PLANNING AND ZONING COMMISSION MEETING

City Council Chambers, 33 East Broadway Avenue Meridian, Idaho
Thursday, January 05, 2023 at 6:00 PM

Agenda

A. Proposed Site Plan (dated: 4/20/2022)

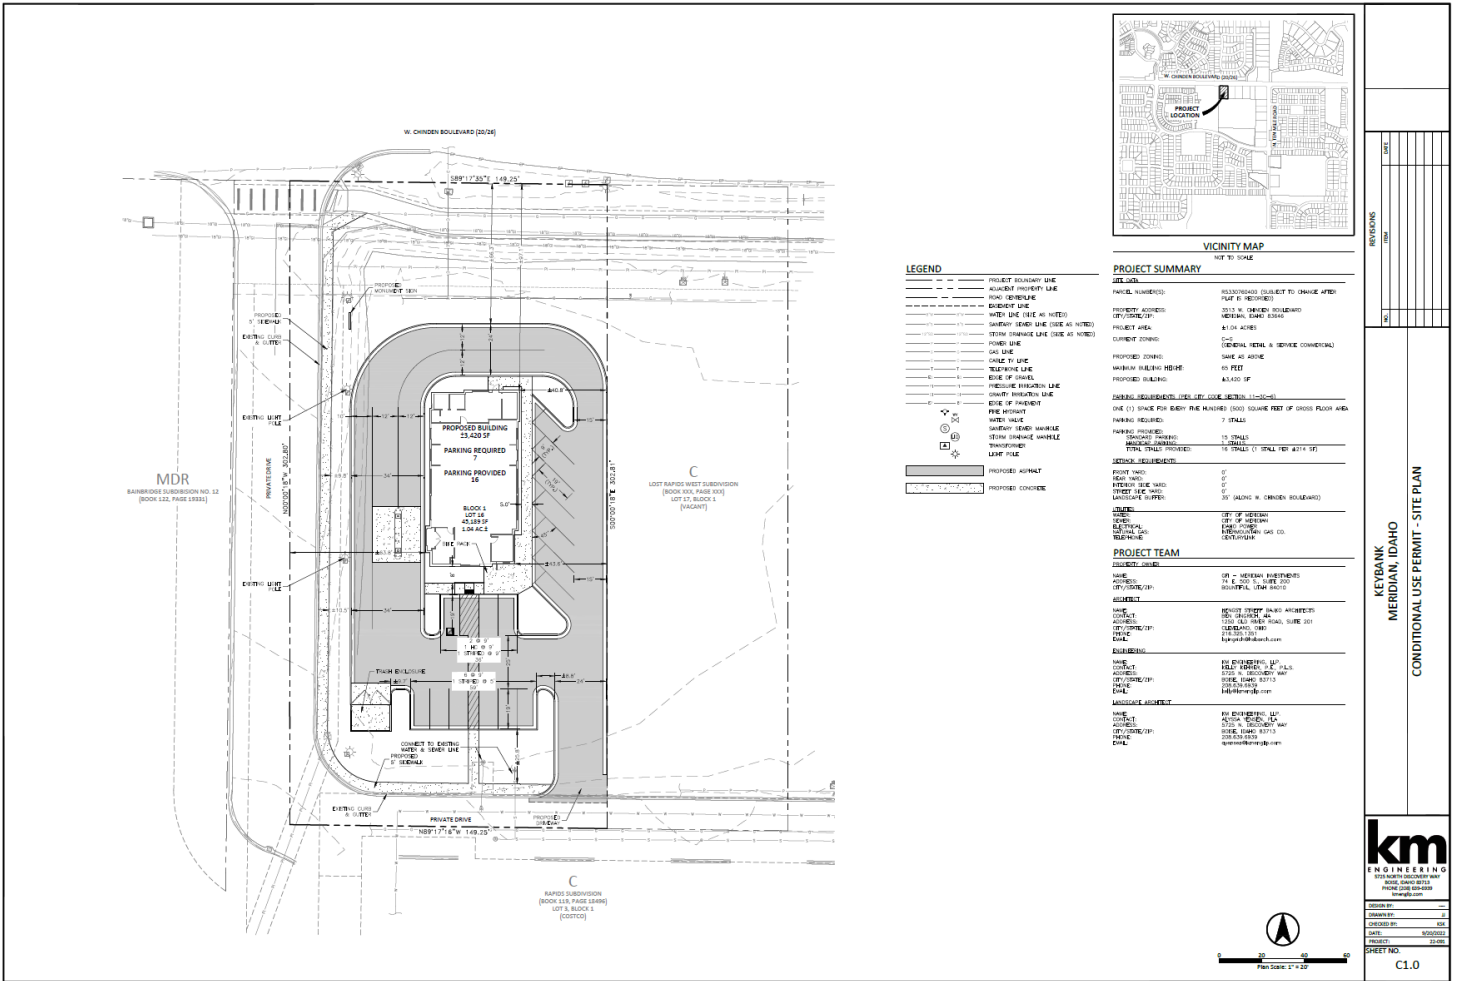
Parking lot landscaping is required to be provided in accord with the standards listed in UDC [11-3B-8C](#). **A minimum 5-foot wide perimeter buffer is required along the east boundary of the site per UDC 11-3B-8C.1, landscaped per the standards listed in UDC [11-3B-8C.1b](#).** The buffer on the adjacent property to the east does not meet this requirement; remove from the plan.

- f. Widen the sidewalk to 7-feet on the south and east sides of the building where parking abuts to allow vehicles to overhang 2-feet (the length of stalls may be reduced to 17-feet); or, provide wheel stops within parking spaces to prevent vehicle overhang in accord with UDC [11-3C-5B.3, 4](#).

- g. Depict a minimum 5-foot wide perimeter buffer along the east boundary of the site per UDC [11-3B-8C.1](#), landscaped per the standards listed in UDC [11-3B-8C.1b](#); remove the buffer on the adjacent property from the plan.

B. Proposed Landscape Plan (dated: 9/20/22)

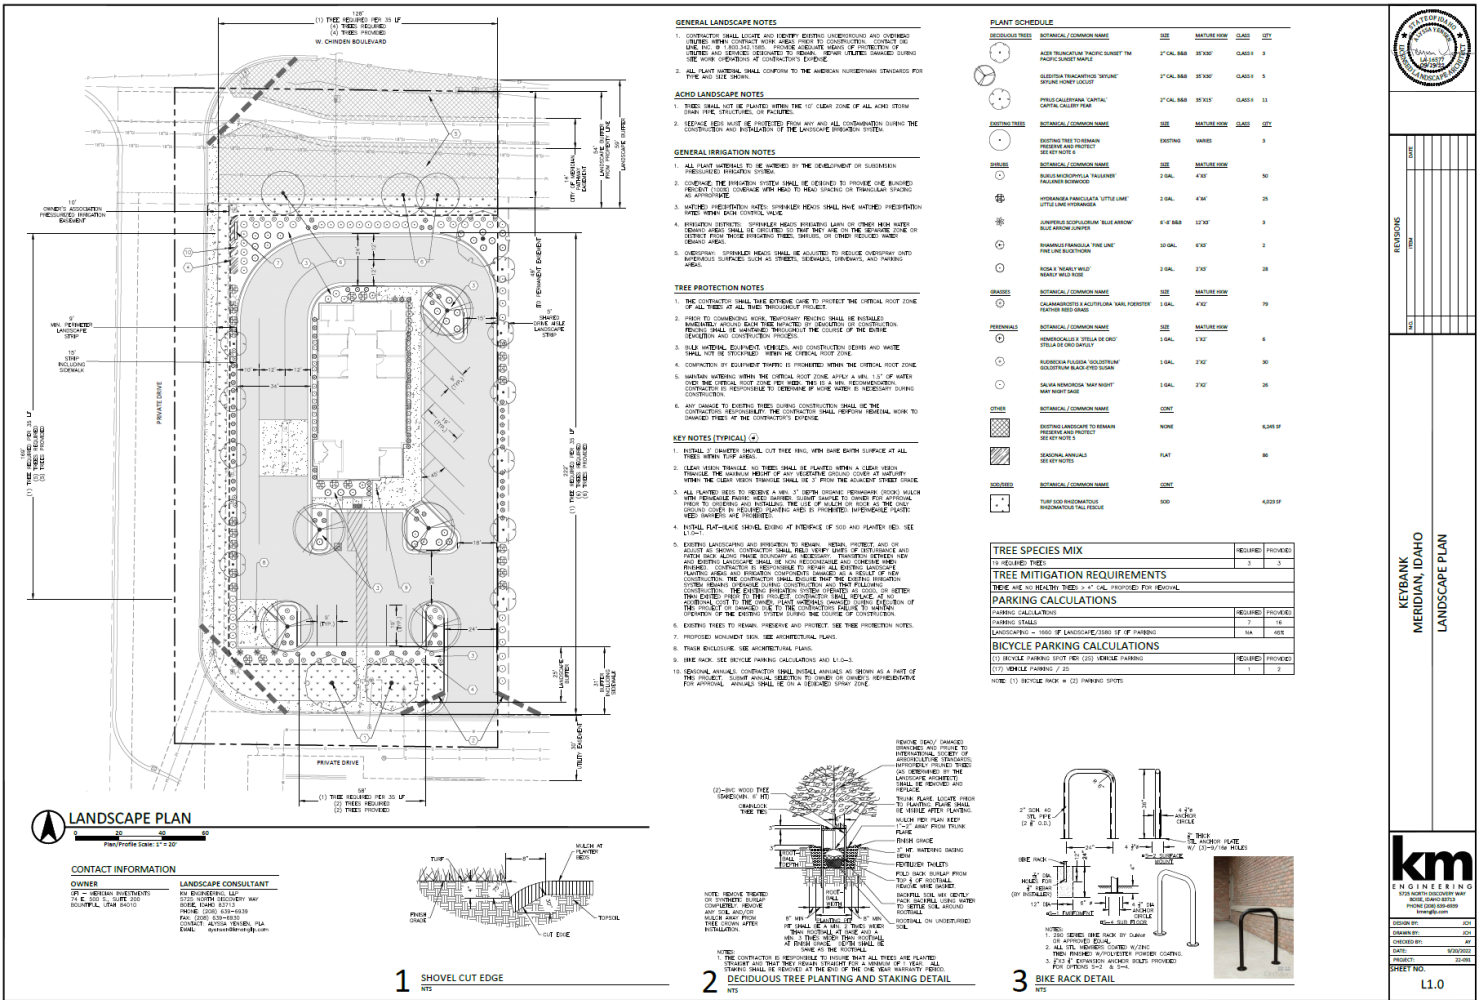
- C. Landscape shrubbery shall be limited to no more than three (3) feet in height between entrances and financial transaction areas and the public street. *The reed grass depicted on the landscape plan in the buffer along the west boundary of the site and the falkner boxwood in the buffer along the northern boundary of the site on the west side of the building has a mature height of 4-feet, which is not allowed; the landscape plan should be revised to comply with this standard.*

- d. Depict shrubbery that is no more than three (3) feet in height at maturity between entrances and financial transaction areas and the public street as set forth in UDC [11-3A-16C](#). *The reed grass within the planter along the west boundary of the site and the falkner boxwood in the buffer along the north boundary of the site exceed 3-feet in height at maturity and should be replaced with shrubbery that meets this standard.*
